December 2021 | Response to Comments

RISE KOHYANG MIDDLE SCHOOL

COMMENT D – Aurora Pink (Page 1 of 3)

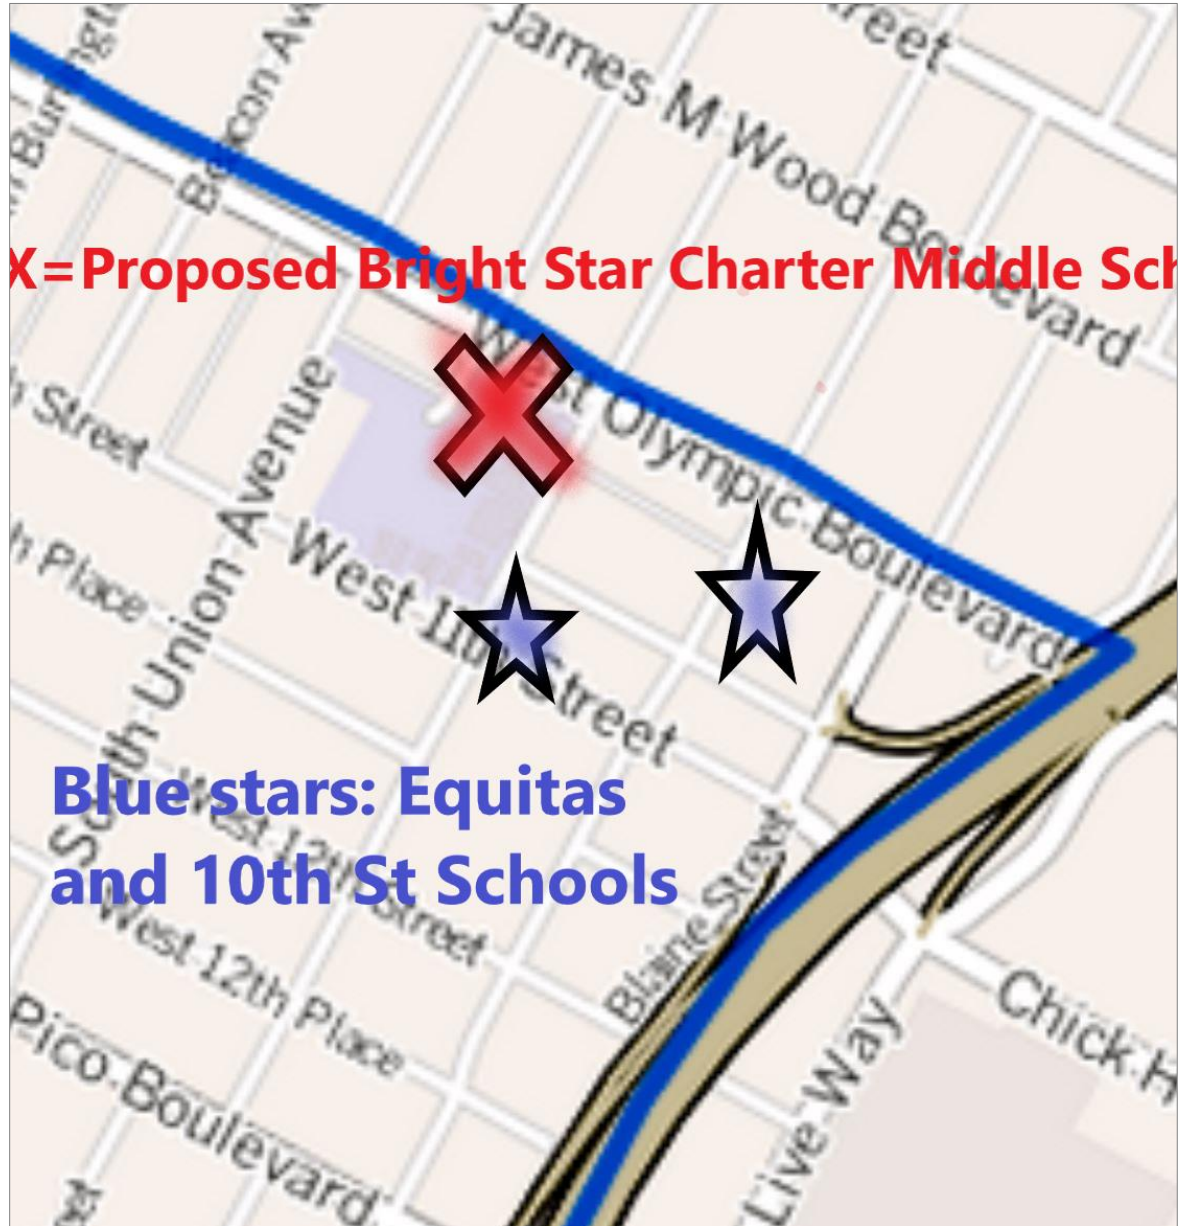
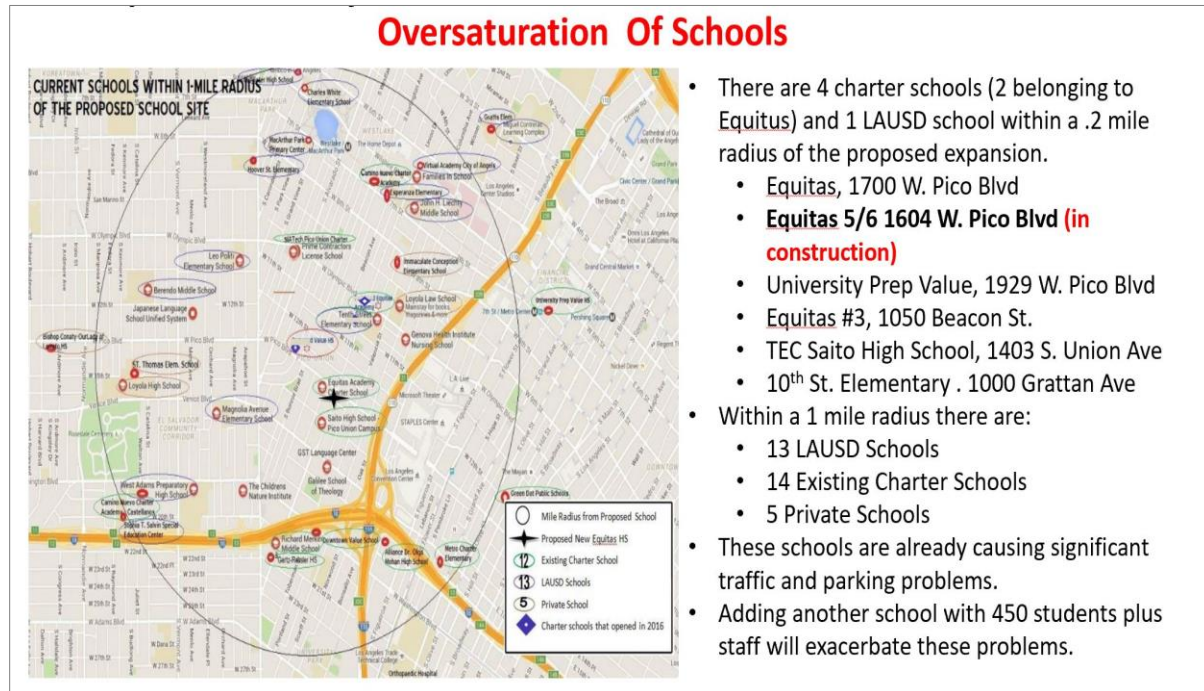
- There is already an oversaturation of schools in this area (See attachment 2)
- Drop-offs and pick-ups from schools cause traffic jams
 - Union Avenue is a highly travelled one lane in each direction street. Every morning and afternoons there is a horrific traffic jam stretching from Olympic heading southbound to 11th Street and westbound on to Beacon.
- Proposed school site is only ½ block away from Equitas on Beacon and 11th and 10TH Street Elementary School (See attachment 1)
 - Residents can only expect more traffic jams and more circulating traffic on neighboring residential streets.

D-1

- D-1 Concerns about the potential for increase in traffic near the Project site due to the amount of schools in the local vicinity are noted.

As discussed in response A-1, there are currently three pre-K through 8th grade schools that were included as part of the baseline existing condition within a quarter-mile of the Project site, including Equitas Academy #3 Elementary Charter, 10th Street Elementary School, and Immaculate Conception School. School hours for the proposed Project would be 8:10 am to 2:45 pm, and some teachers and students may be on campus after school hours; however, the relocated middle school operation hours would differ from the start and end times at the other schools (see Section 3.1.5, *Operation*, of this MND).

Additionally, as discussed in the Transportation Impact Assessment (TIA) that was prepared for the proposed Project (see Appendix G of this MND), it was determined that the proposed Project's weekday AM and PM peak hour traffic volumes would not cause or substantially extend vehicle queuing at the intersections of Burlington Avenue and Olympic Boulevard, Beacon Avenue and Olympic Boulevard, and Beacon Avenue and 11th Street. Student loading and unloading would occur in the on-site drop-off/pick-up area located within the existing alley (see Figure 6b, *Conceptual Site Plan (Level 1)* of this MND). The drop-off/pick-up area can effectively accommodate one lane of queued vehicles (15 vehicles), plus a bypass lane to allow vehicles to bypass the queue should there be delay related to the passenger loading/unloading of one or more of the queued vehicles.
